FIRST AMENDMENT TO THE  
DRAFT  
ENVIRONMENTAL IMPACT REPORT

GOBLE LANE  
MIXED-USE DEVELOPMENT  
FOR PLANNED DEVELOPMENT  
REZONING  
PDC02-066/NR05-001

SCH No. 2005022057

City of San José  
June 2005

Figure 6 REVISED  
Existing Condition  
Intersection Traffic Volumes  
Weekday AM and PM Peak Hour

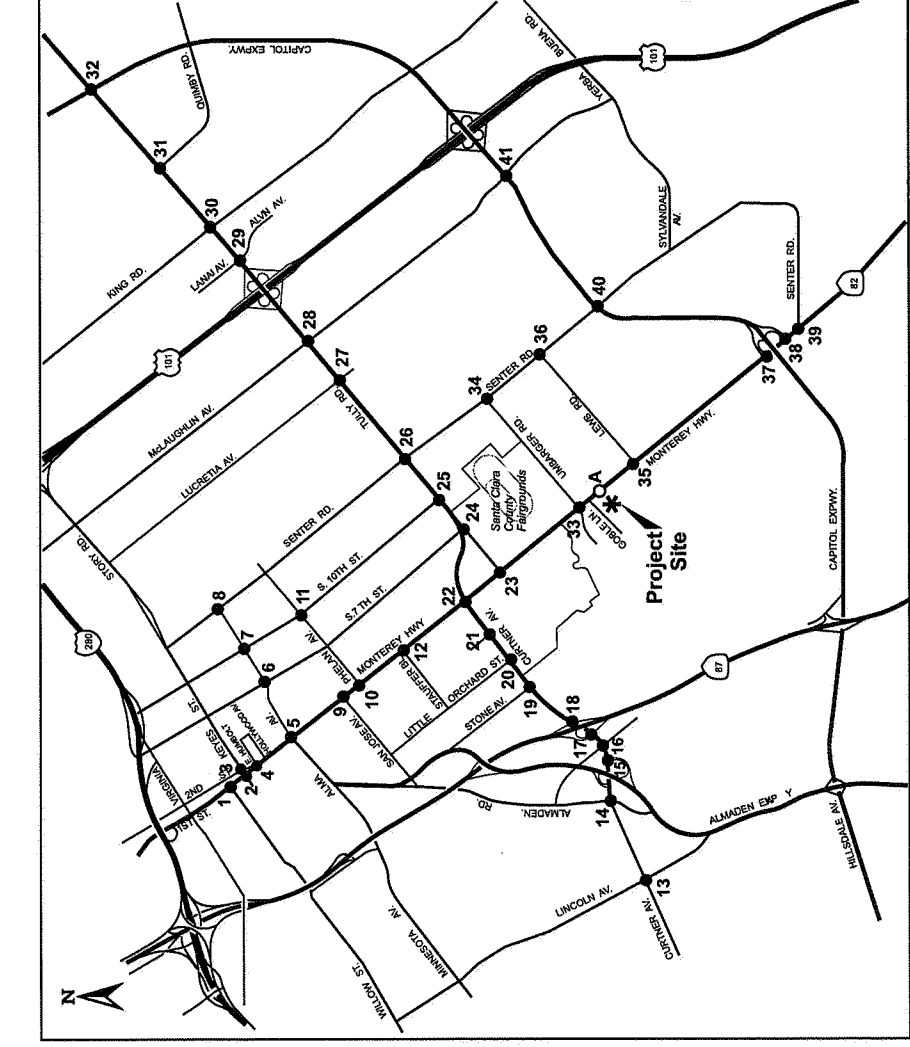
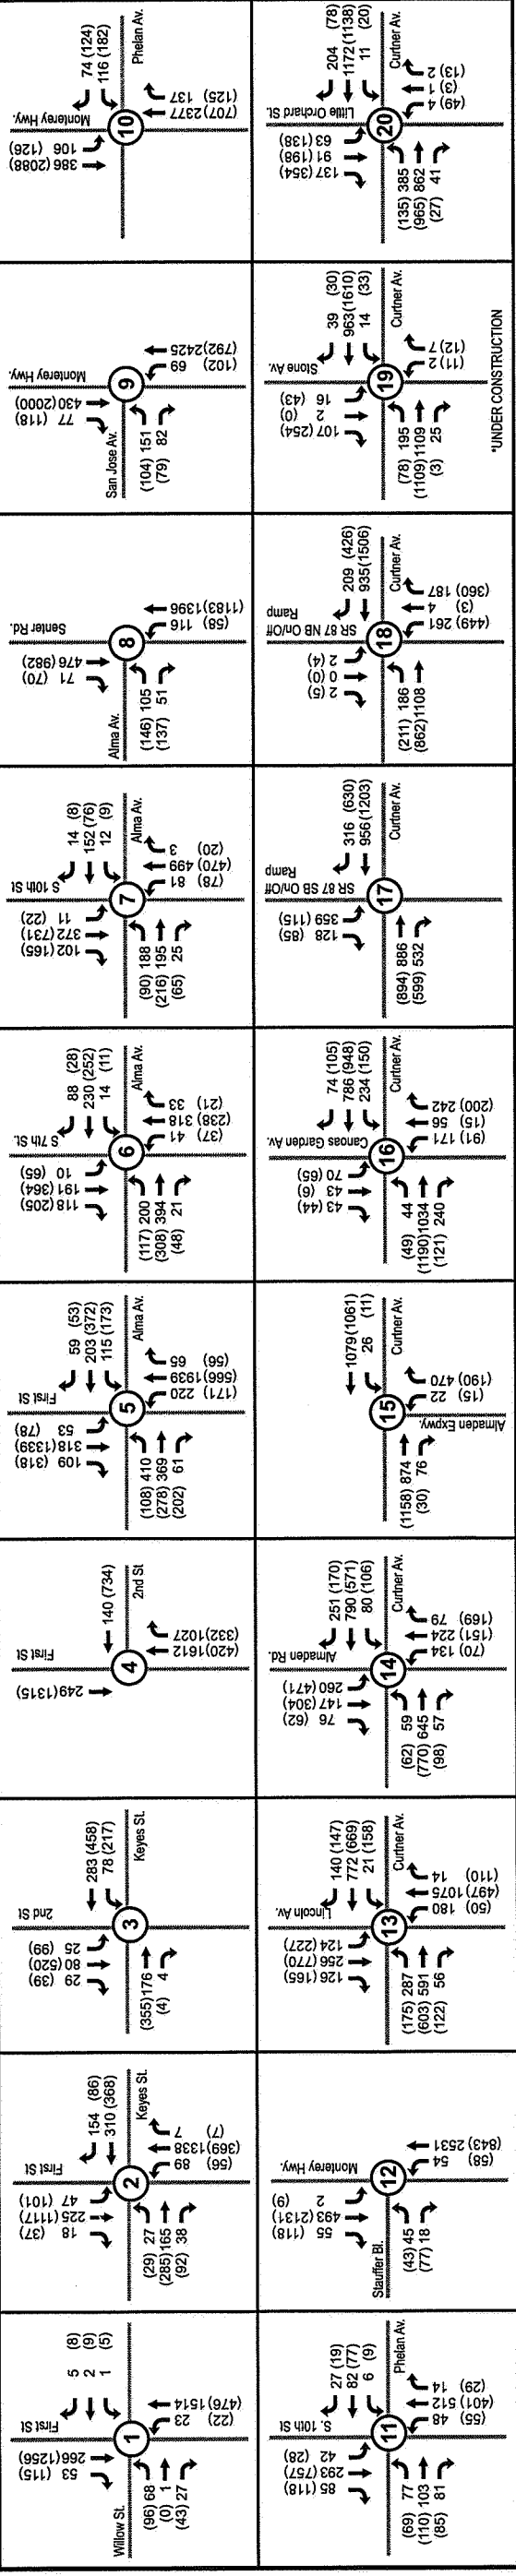
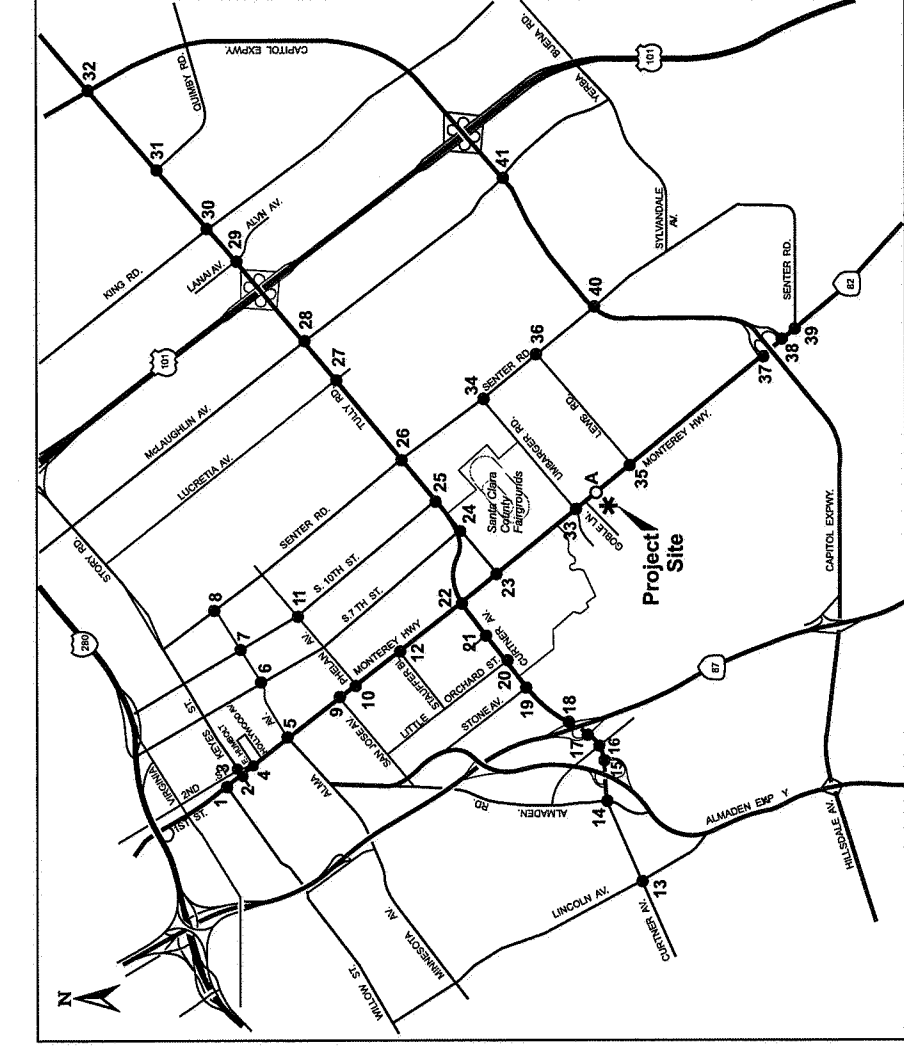
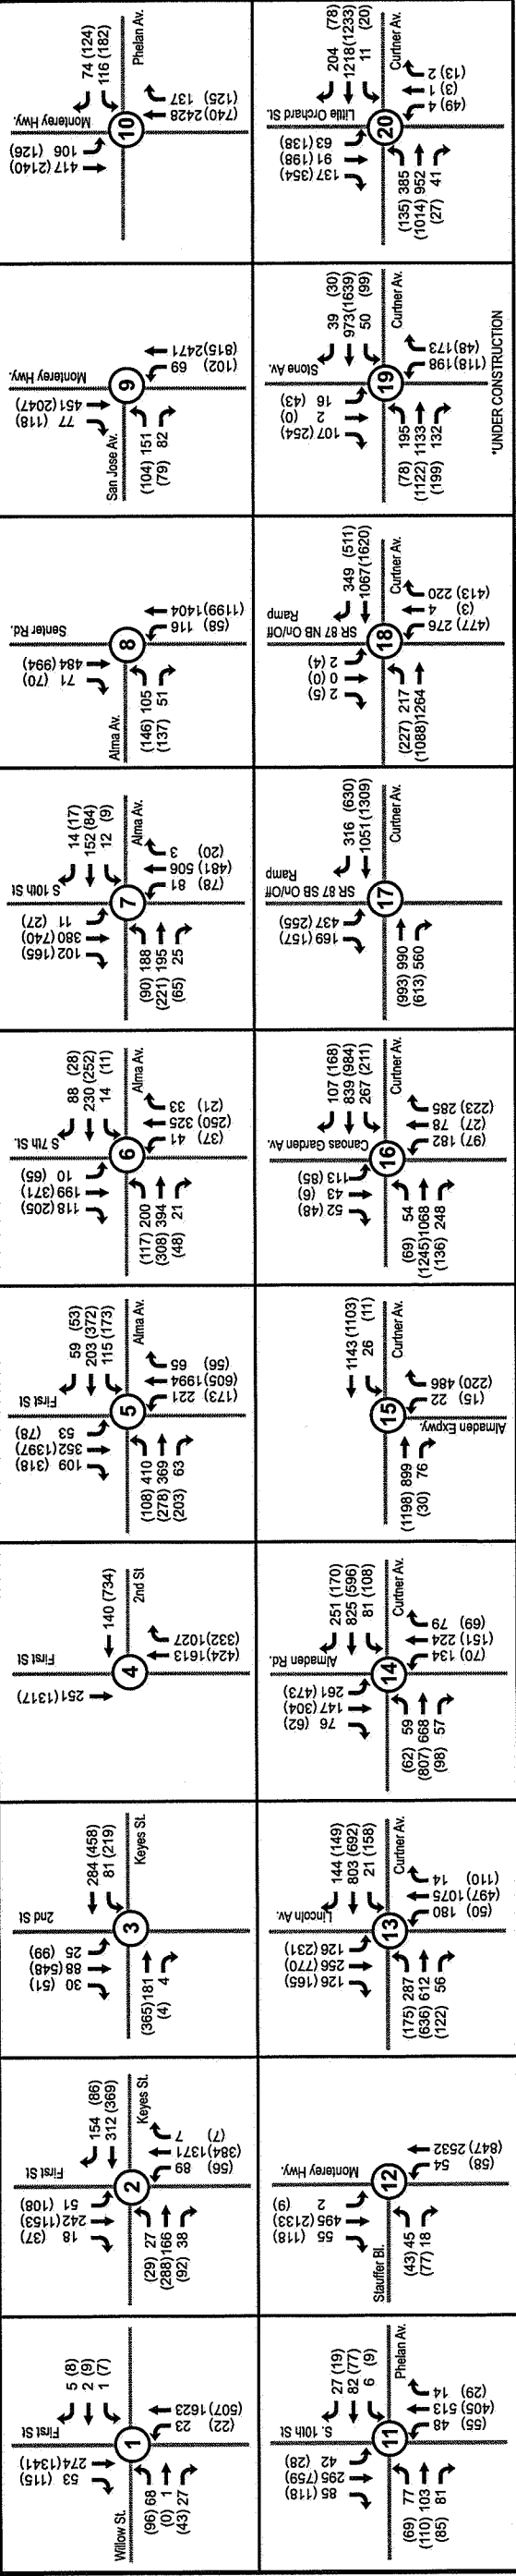
**Comment C18:** Figure 6: Volumes shown in this figure do not match volumes used in intersection analysis (Traffix) for intersections #2, #3 and #9. Which volumes are correct?

**Response C18:** The intersection analysis and volumes shown on the TRAFFIX worksheets are correct. Changes have been made to the Figure 6 to reflect the correct turning movement volumes. The corrections do not affect the impacts conclusions of the Draft EIR. The revised Figure 6 (page 20) is provided in Section IV of this document.

Figure 7 REVISED  
Background Condition  
Intersection Traffic Volumes  
Weekday AM and PM Peak Hour

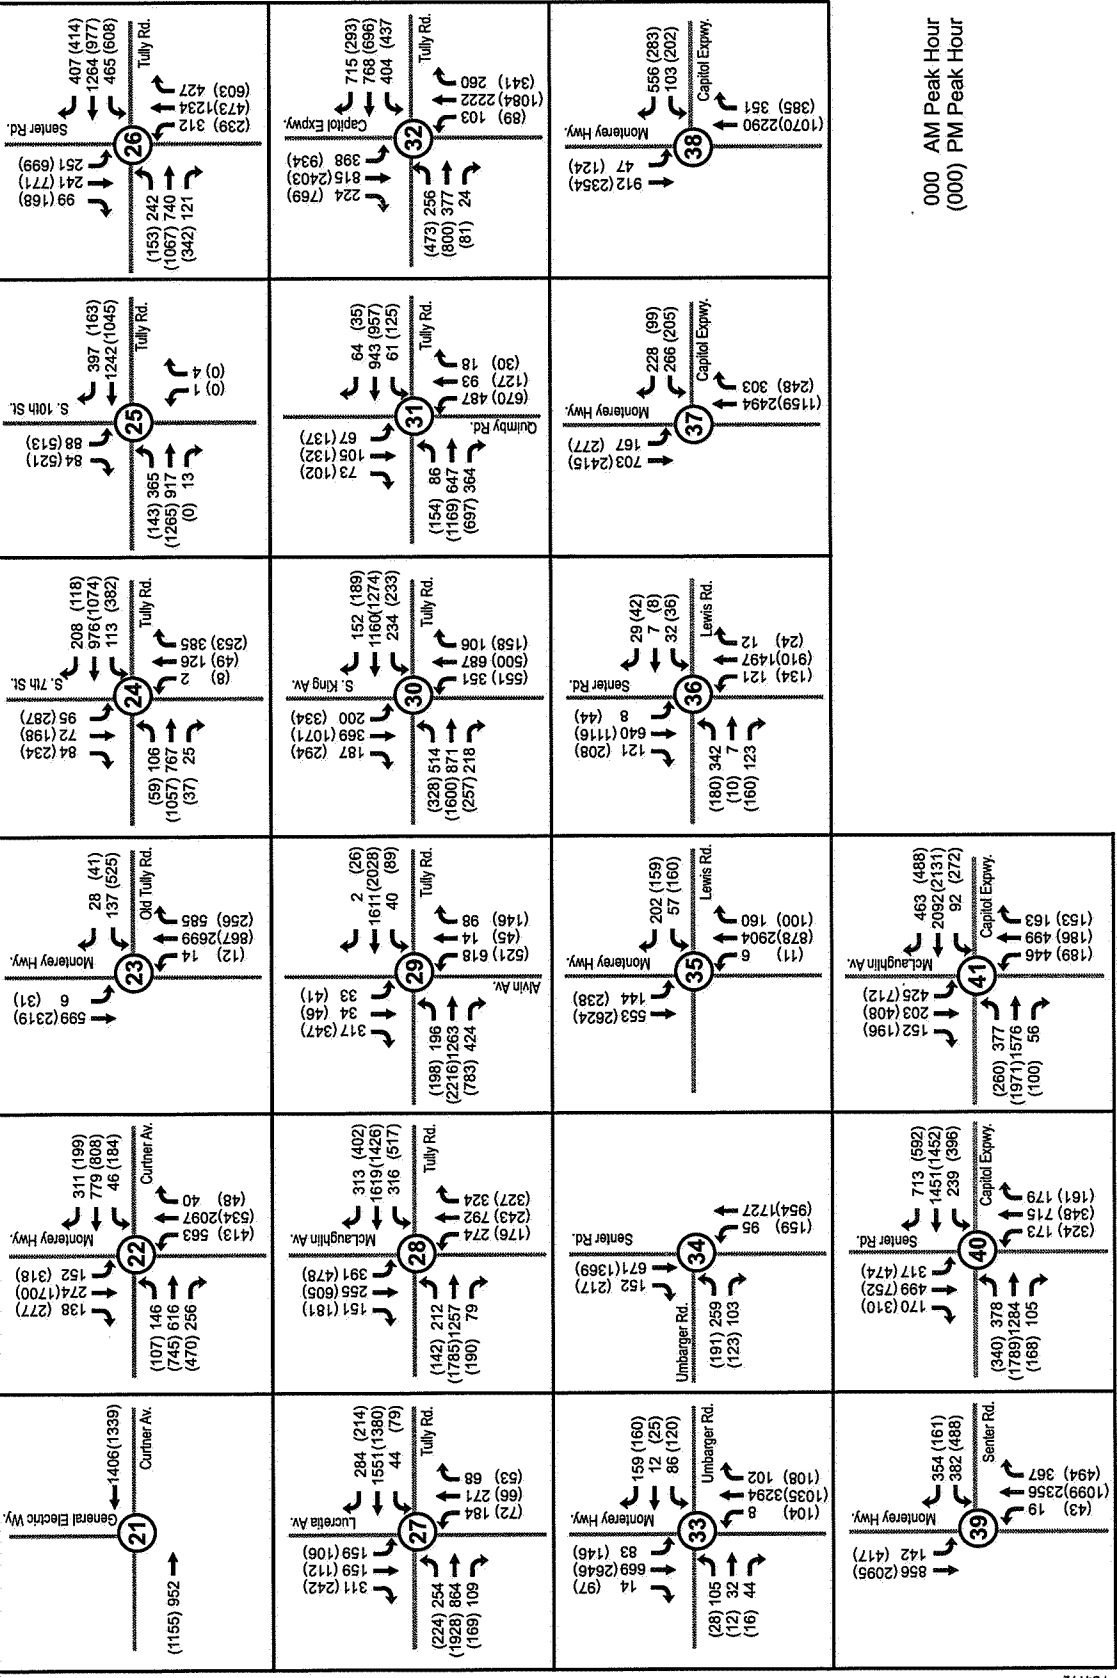
**Comment C19:** Figure 7: Volumes shown in this figure do not match volumes used in intersection analysis (Traffix) for intersections #1, and #22. Which volumes are correct?

**Response C19:** The intersection analysis and volumes shown on the TRAFFIX worksheets are correct. For intersection #22 the volumes do match and no edit is required. Changes have been made to the Figure 7 to reflect the correct turning movement volumes for intersection #1. The corrections do not affect the impacts conclusions of the Draft EIR. The revised Figure 7 (page 24) is provided in Section IV of this document. A complete copy of the revised TIA will be provided to Caltrans.

**Figure 11 REVISED**  
**Project Condition**  
**Intersection Traffic Volumes**  
**Weekday AM and PM Peak Hours**

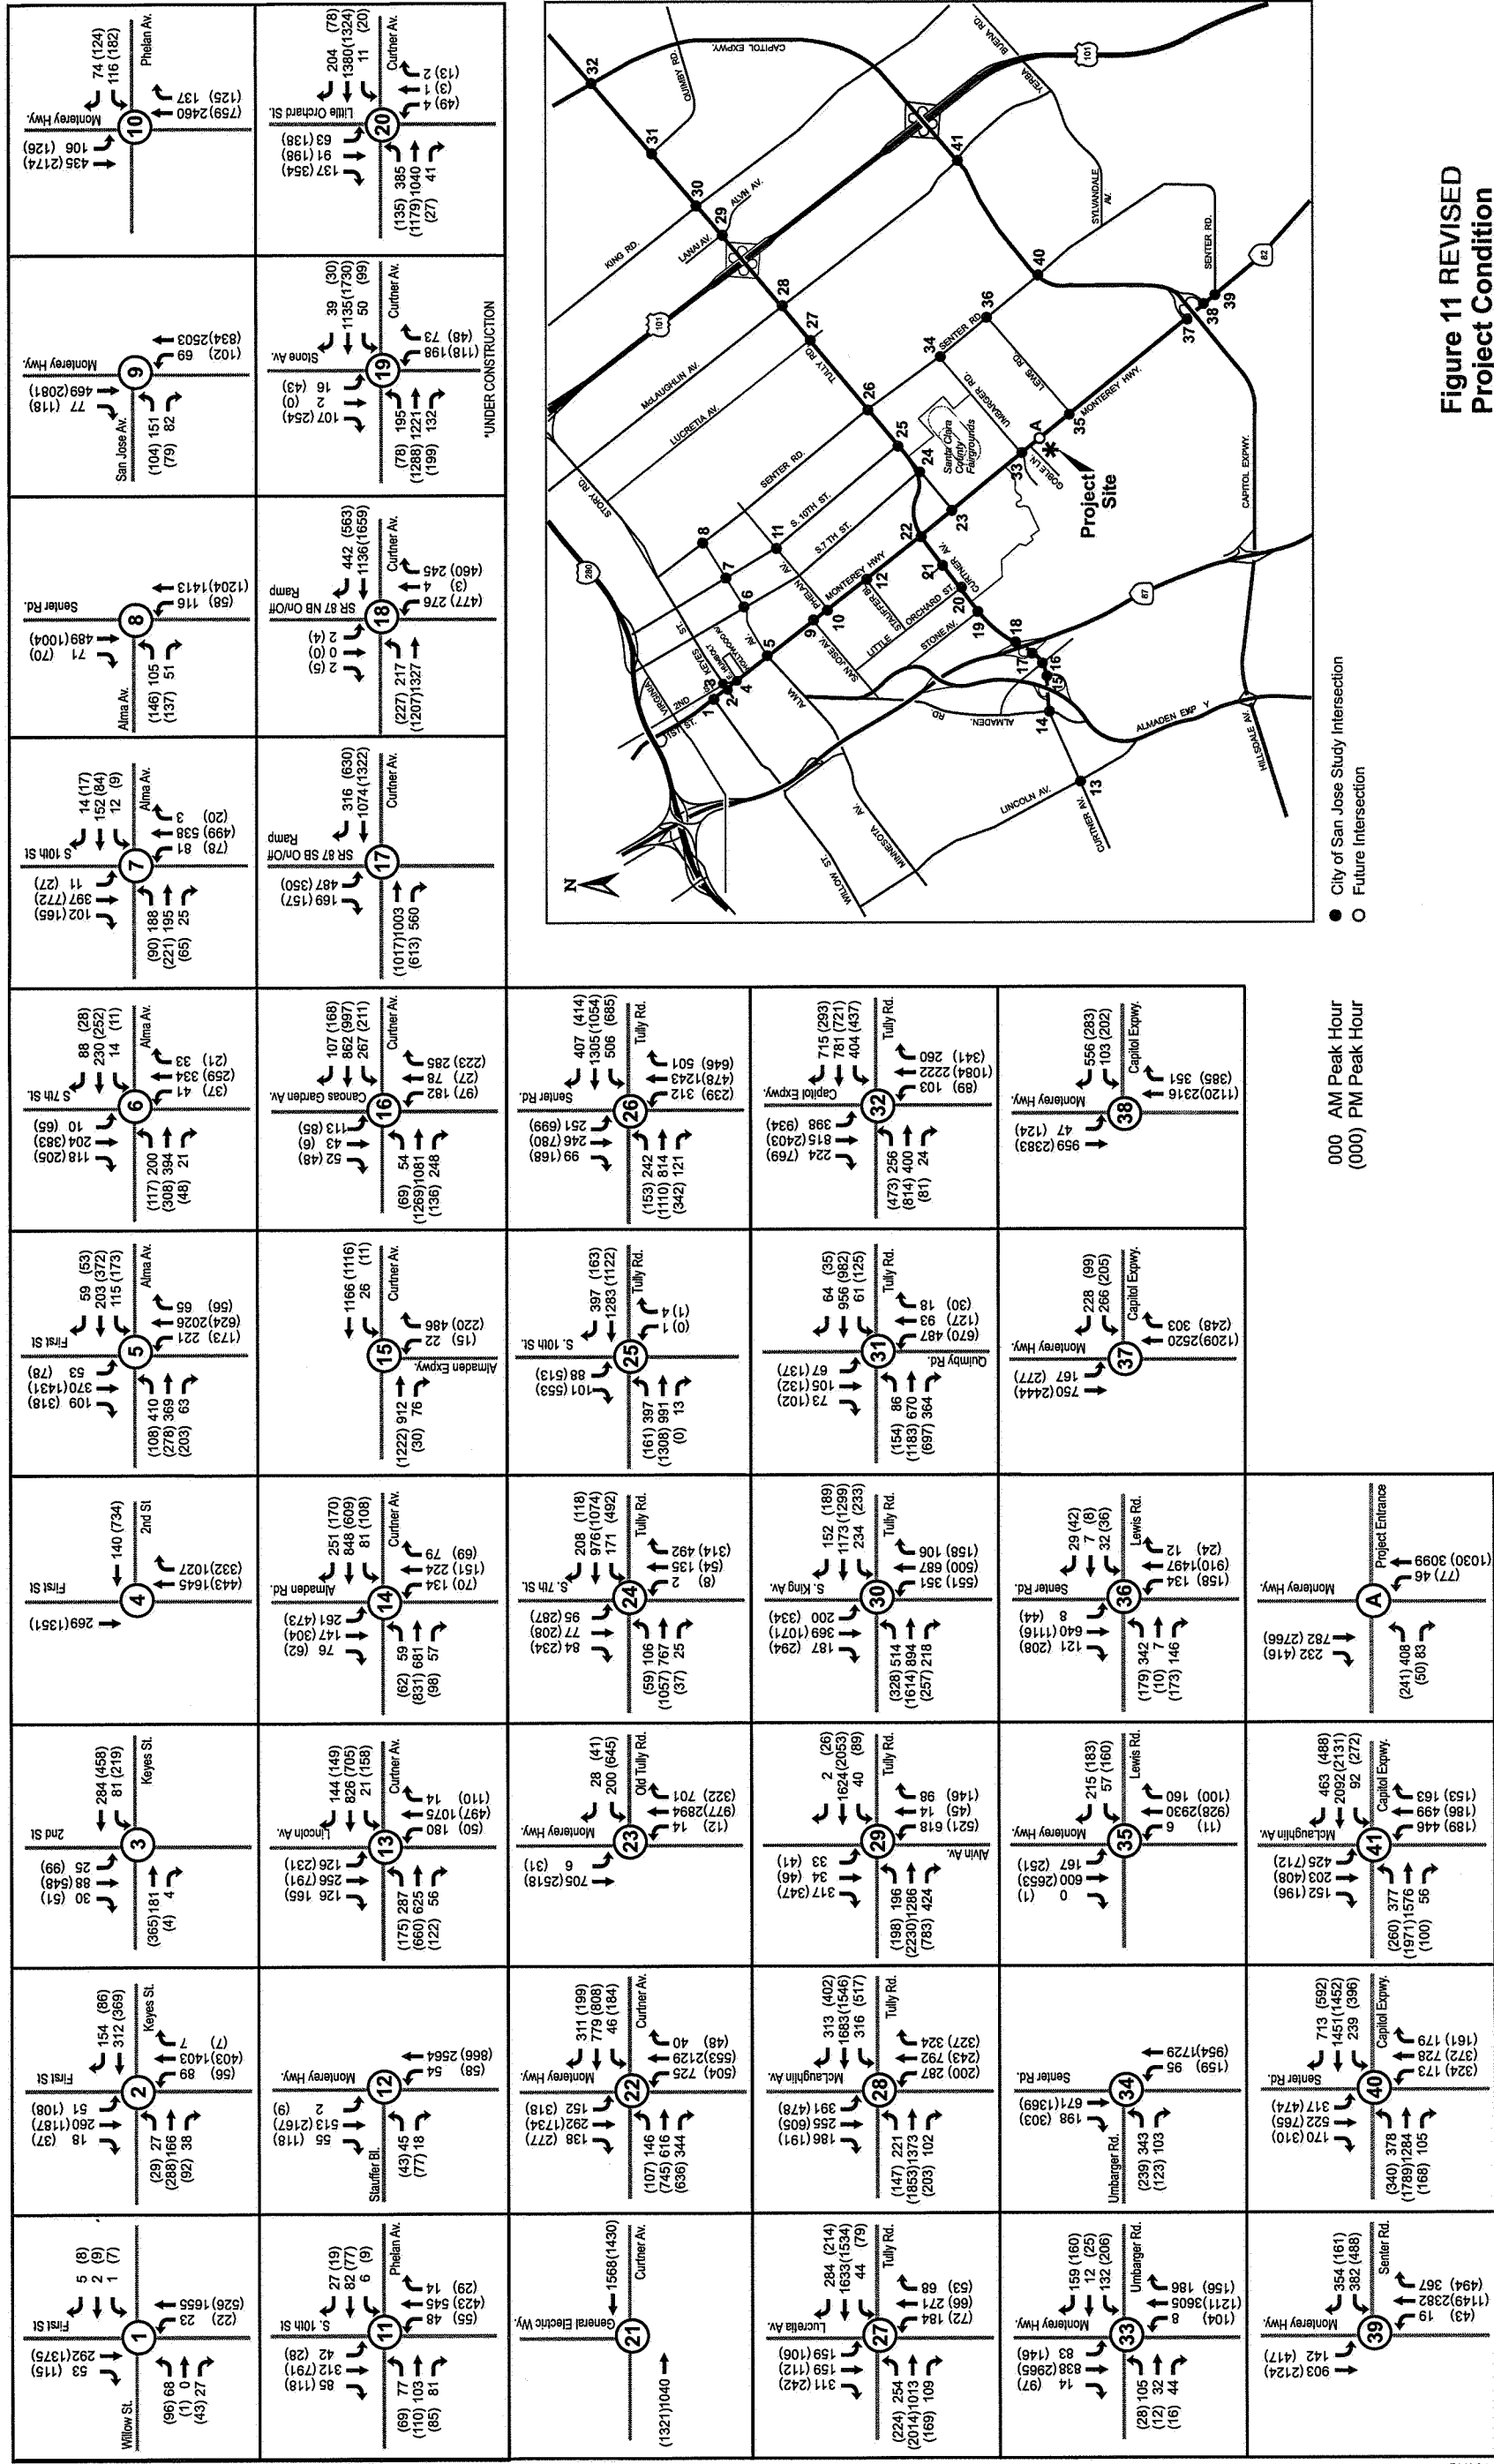
**Comment C20:** 20. Figure 11: Volumes shown in this figure do not match volumes used in intersection analysis (Traffix) for intersections #23, and #35. Which volumes are correct?

**Response C20:** The intersection analysis and volumes shown on the TRAFFIX worksheets are correct. Changes have been made to the Figure 11 to reflect the correct turning movement volumes. The corrections do not affect the impacts conclusions of the Draft EIR. The revised Figure 11 (page 33) is provided in Section IV of this document. A complete copy of the revised TIA will be provided to Caltrans.
